SUPPLEMENTAL FINAL ENVIRONMENTAL IMPACT STATEMENT

***THE LANDMARK AT
EASTVIEW
MOUNT PLEASANT
ENTITLEMENTS 2***

**777 OLD SAW MILL RIVER ROAD
TOWN OF MOUNT PLEASANT
WESTCHESTER COUNTY, NY**

Date: June 22, 2016

FIGURE: IV: H-1

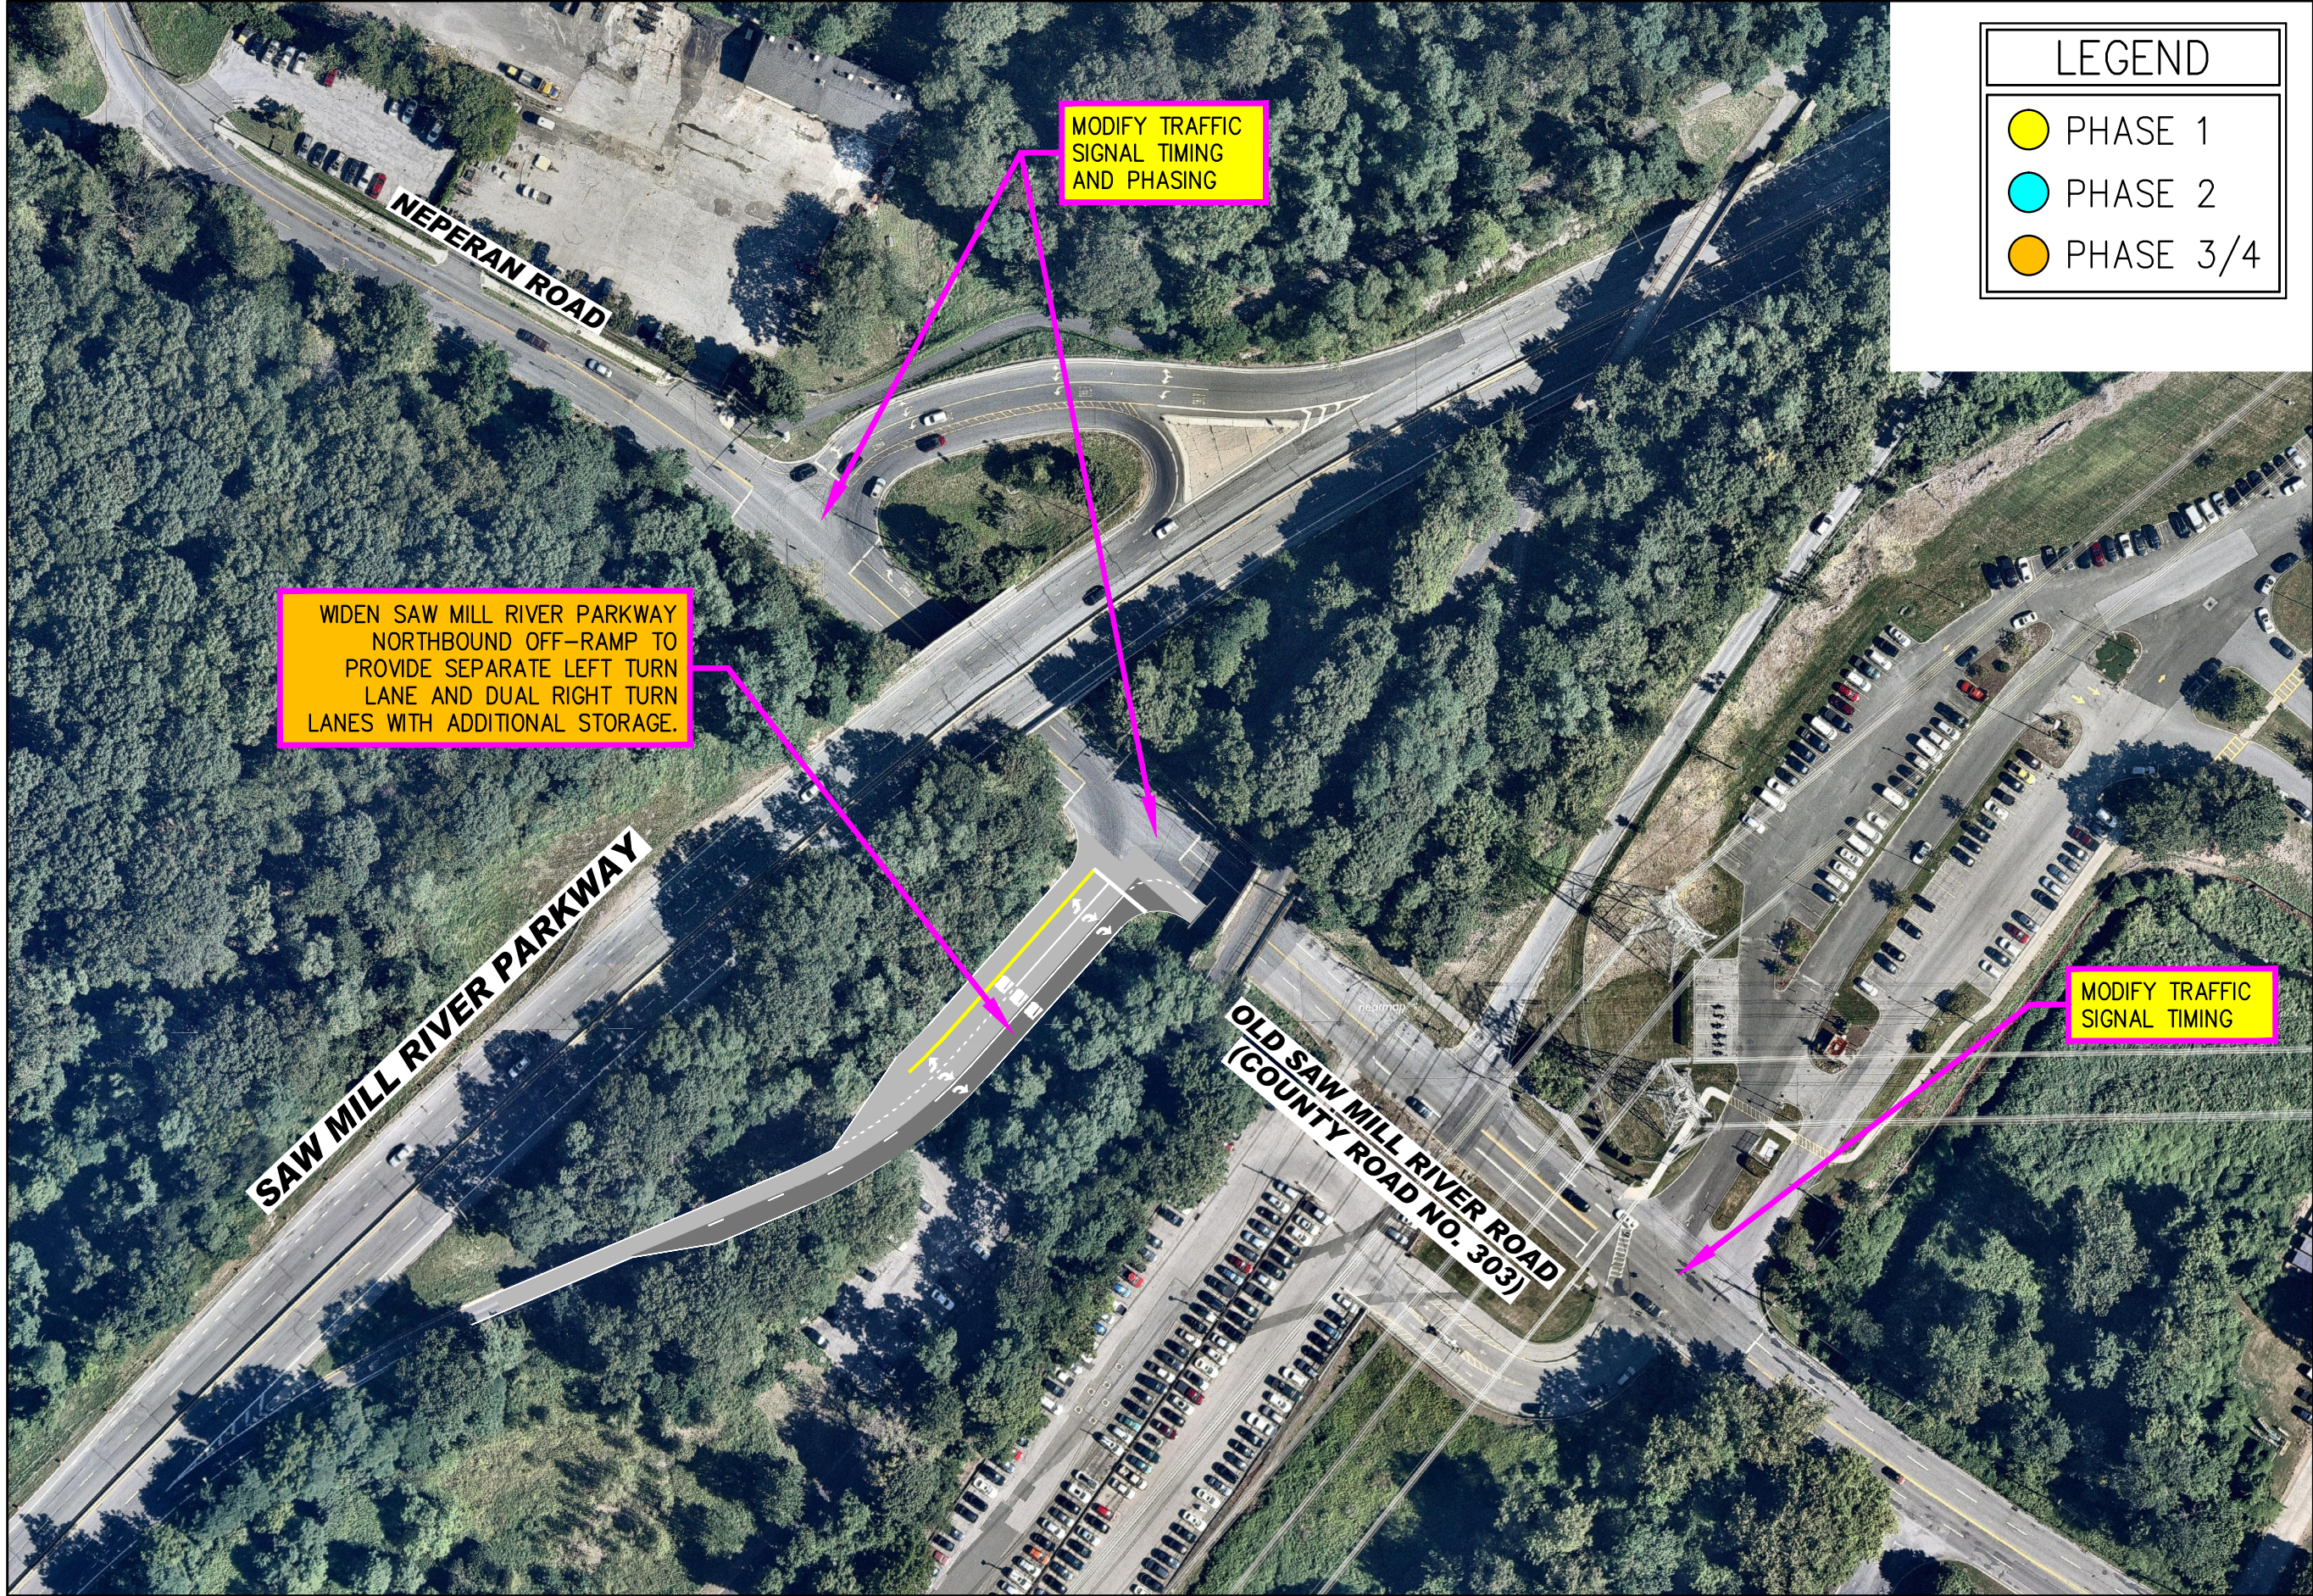
Comment 8-18

The Saw Mill River Parkway northbound off-ramp currently operates at a level of service D and is projected to operate over capacity at a level of service F under each no-build scenario during the peak weekday AM hour. At this intersection as a Phase 1 improvement, traffic signal phasing and timing improvements are proposed which would reduce delays and associated queuing. Additionally as a Phase 3/4 improvement, the northbound off-ramp is proposed to be extended and widened to provide a separate left turn lane and dual right turn lanes. This Phase 3/4 improvement will provide additional capacity and minimize queuing. With the proposed improvements, the overall intersection with the northbound off-ramp is projected to operate at a level of service C with the off-ramp operating at a level of service D. The proposed improvements are depicted and mentioned on Figure IV.H-1.

The northbound left turn at the intersection of Old Saw Mill River Road and Grasslands Road currently operates over capacity at a level of service F. As mentioned in the SDEIS, this intersection is proposed to be monitored for a potential installation of a traffic signal, the need for which will depend on actual future volumes from the Site and other area traffic. Monitoring is proposed to be performed upon completion of each phase of the proposed development. See Response 8-3 for traffic signal warrant analysis at this intersection based on projected future volumes. Tables D-2 and D-3 included in the SDEIS depict the intersection operations for this intersection with a potential traffic signal which projects the northbound approach operating at a level of service D during the peak weekday AM and PM hours. The overall intersection is projected to operate at a level of service B with the potential traffic signal.
